Mr. Dwight Russell, P.E.
Municipal Solid Waste Permits Section – MC 124
Texas Commission on Environmental Quality
12100 Park 35 Circle; Bldg. F
Austin, Texas 78753

Re: Pescadito Environmental Resource Center - Webb County
Municipal Solid Waste (MSW) Permit Application No. 2374
Notice of Deficiency - Technically Complete Permit Application Supplement Number 5
Tracking No. 21876231; CN603835489/RN106119639

APTIM Environmental and Infrastructure, Inc. is in receipt of your letter dated October 23, 2017 in which you are asking for additional information and clarification related to our submittal of August 17, 2017.

**FACILITY SURFACE WATER DRAINAGE REPORT
 DETENTION BASIN PLAN, PROFILE, AND DETAILS**

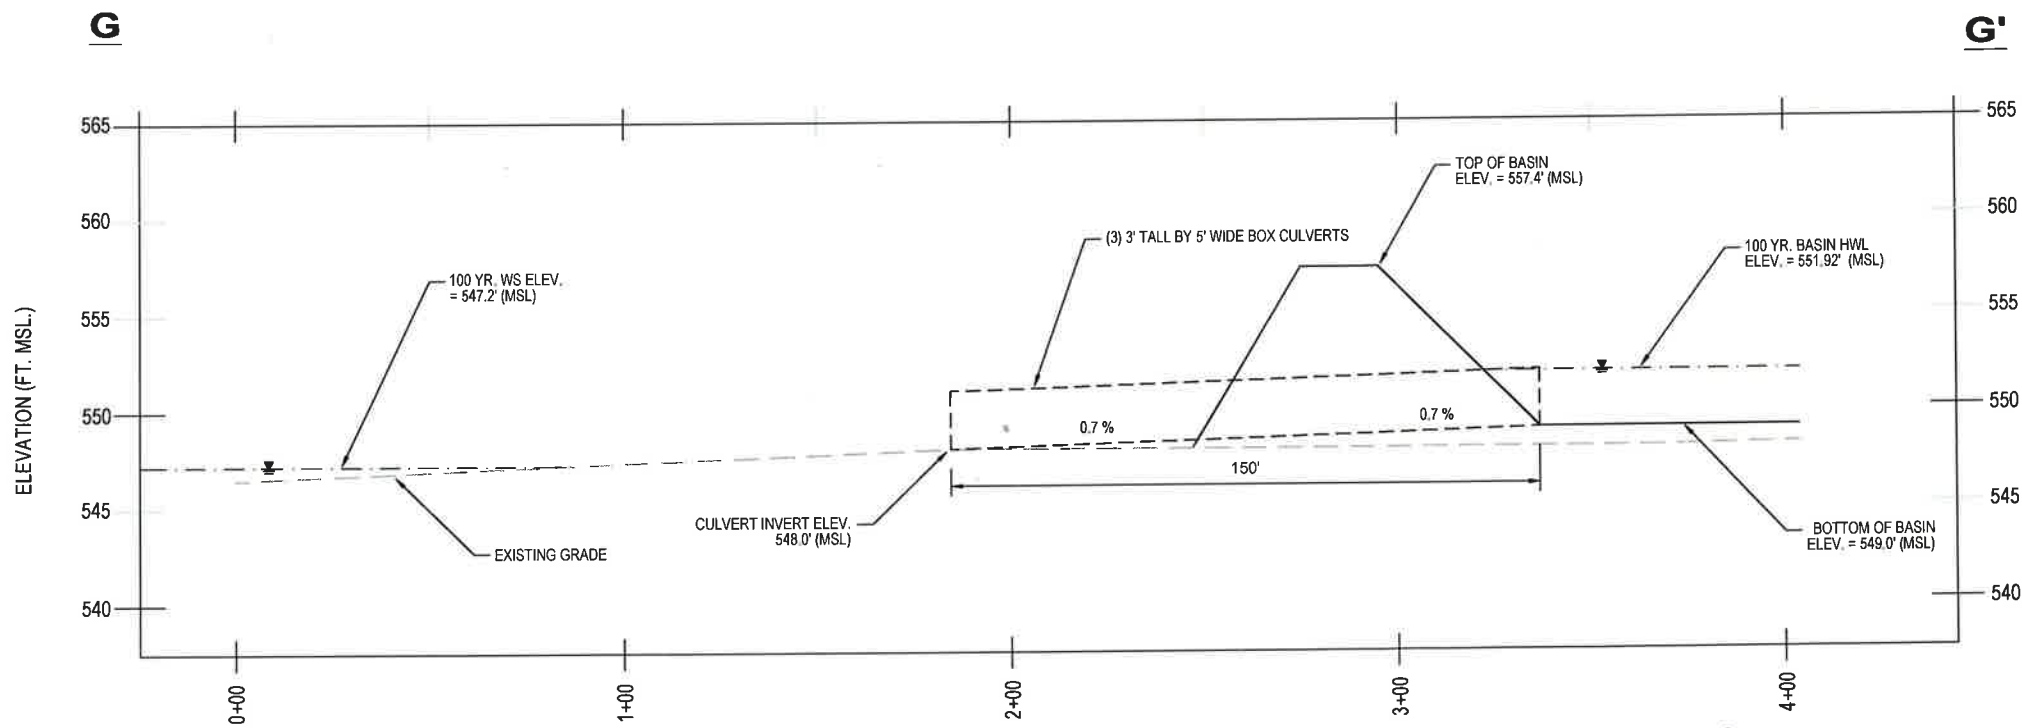
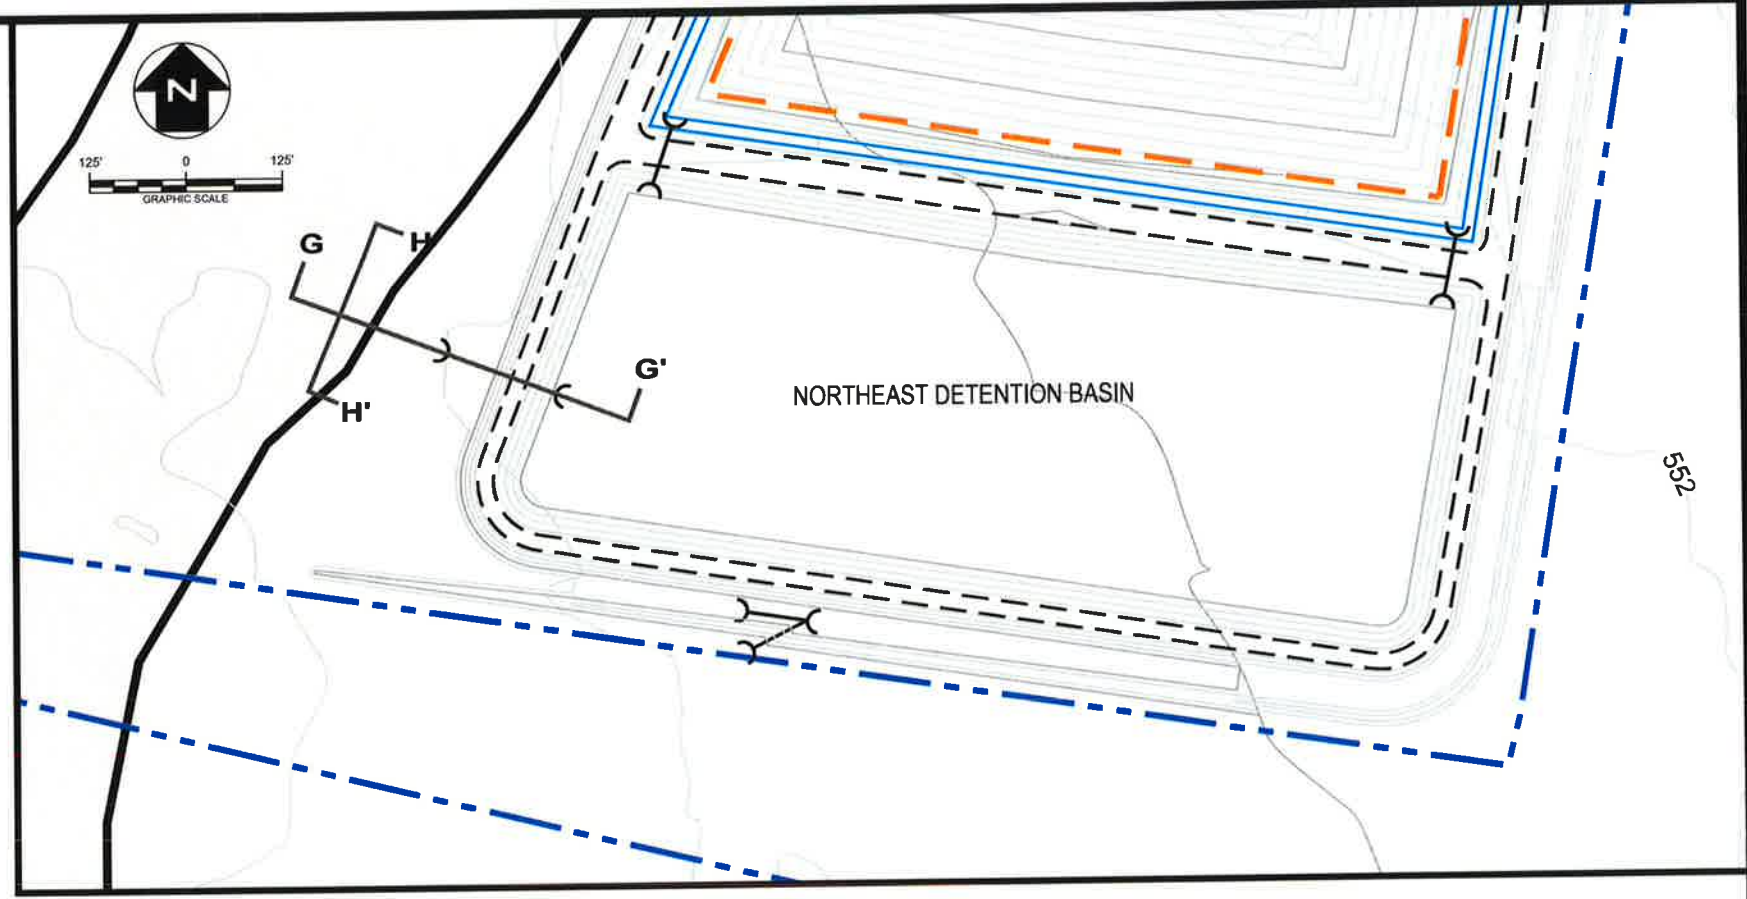
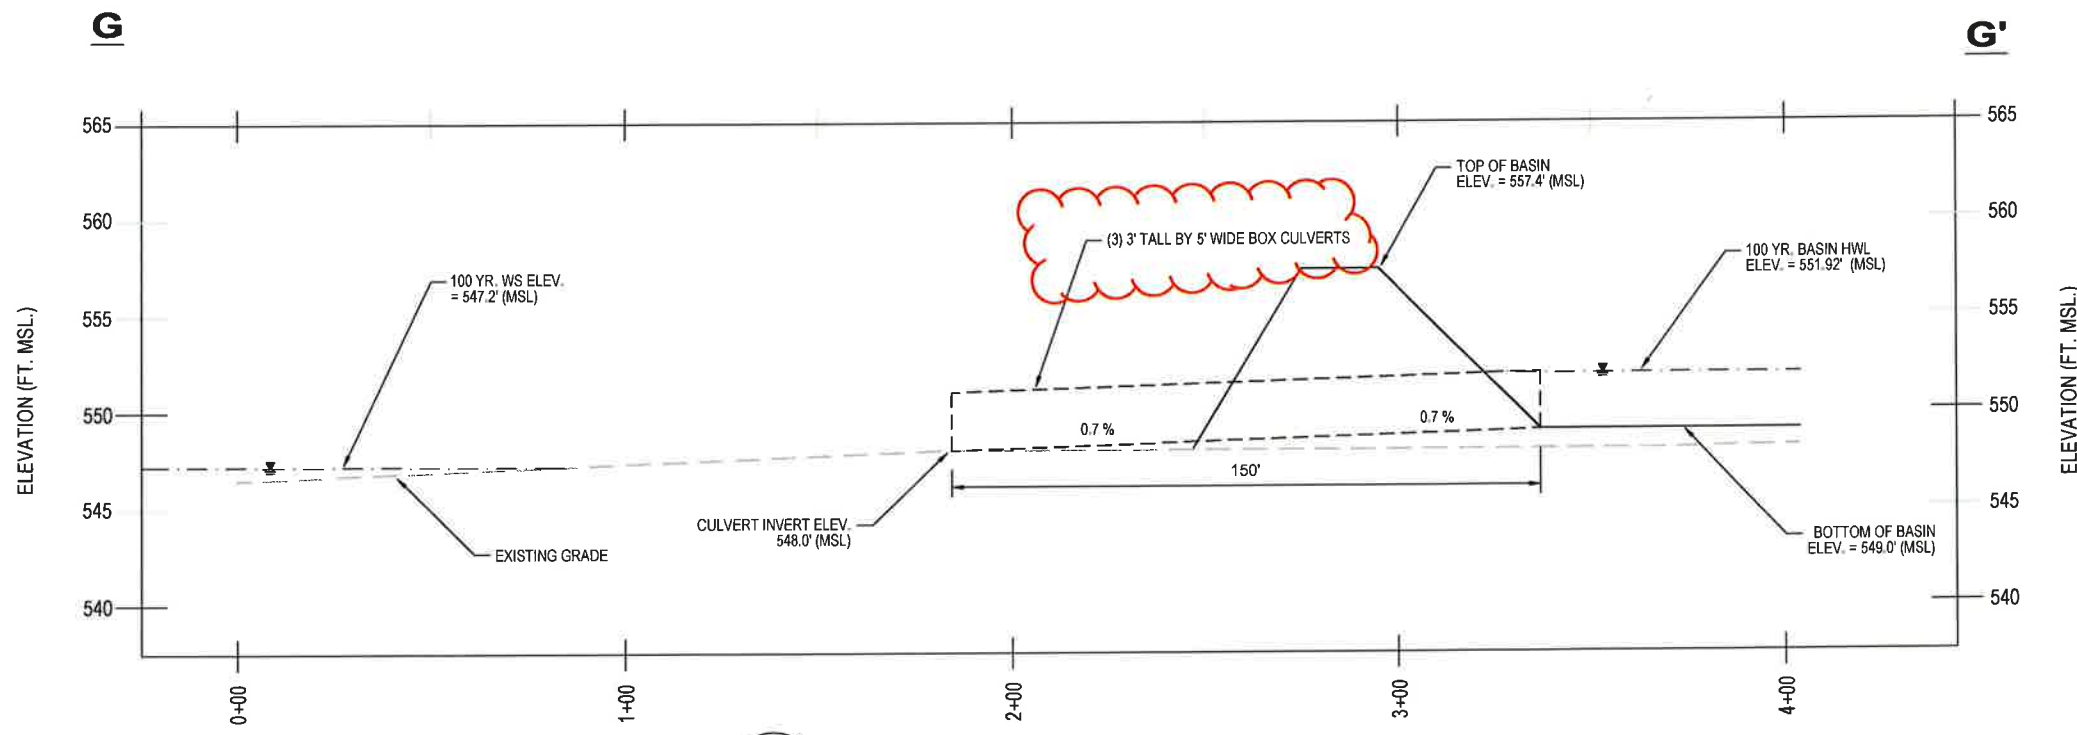
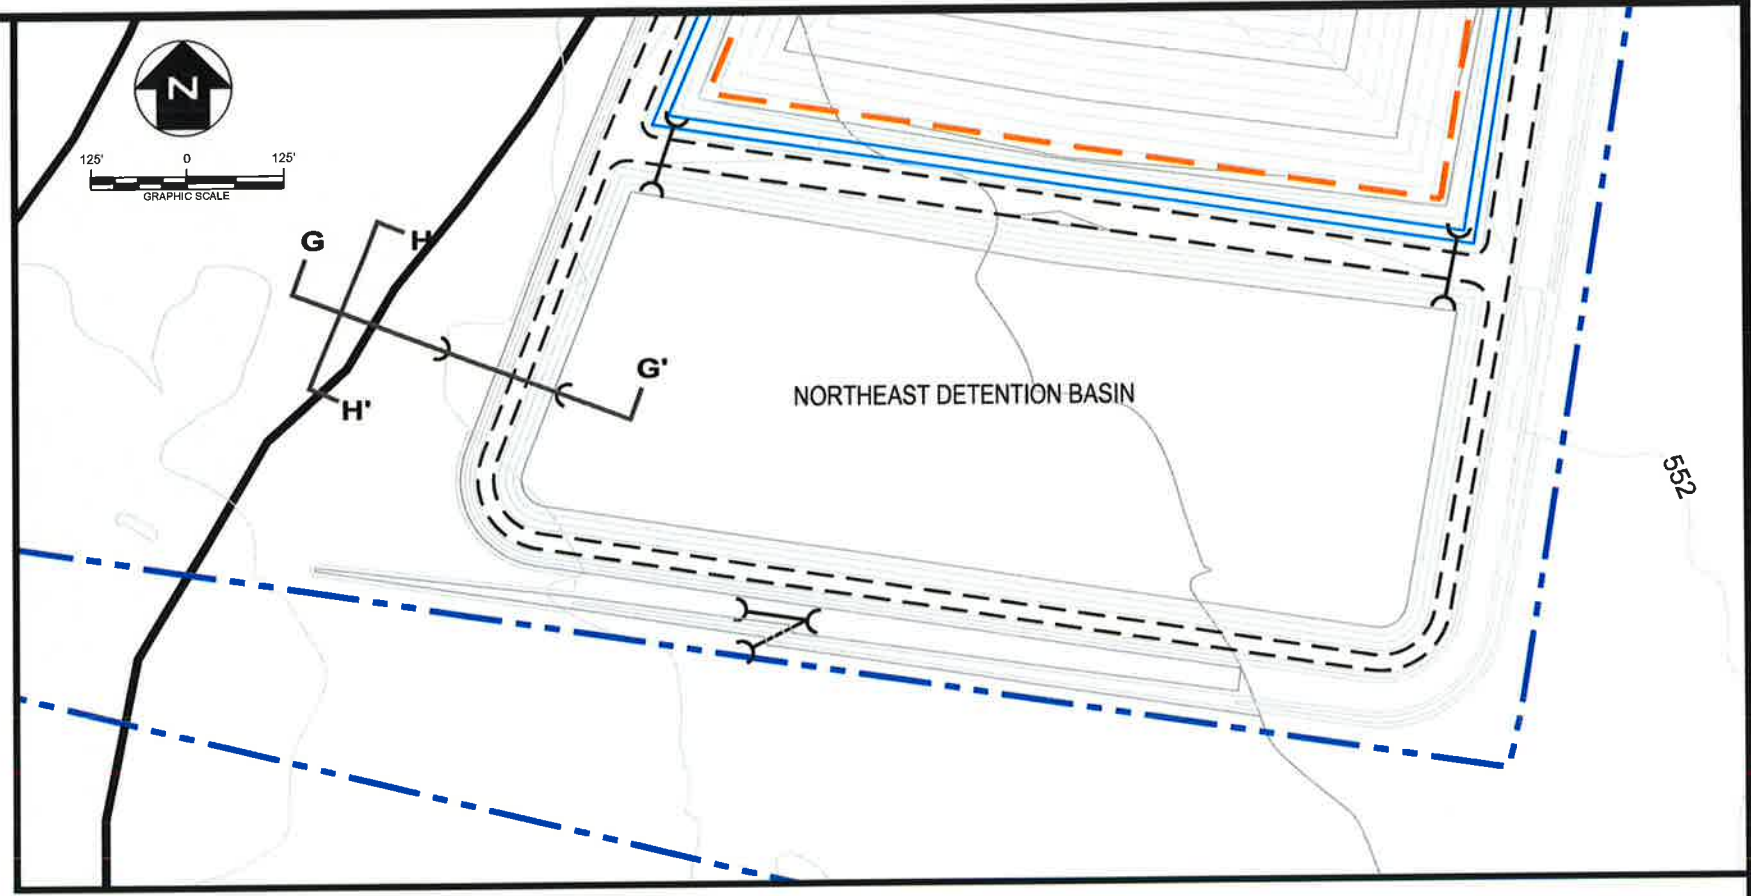
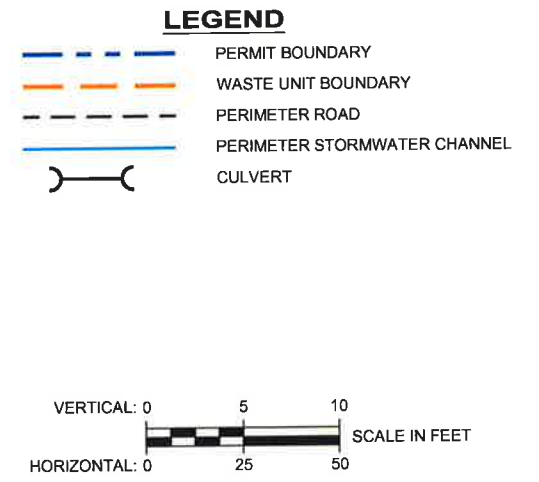
- 5) Attachment III-C, Appendix III-C.1, Page 17 states that the discharge structure for the detention pond consists of three culverts, each 5 feet wide by 3 feet tall. Drawing III.C.2-16 shows the discharge structure as three culverts, each 3 feet wide by 6 feet tall. Please correct as necessary.

Drawing III-C.2-16 has been updated to reflect the correct culvert size. Three culverts 5-feet wide and 3-feet tall are proposed. The text on Page 17 of Appendix III-C.1 is correct.
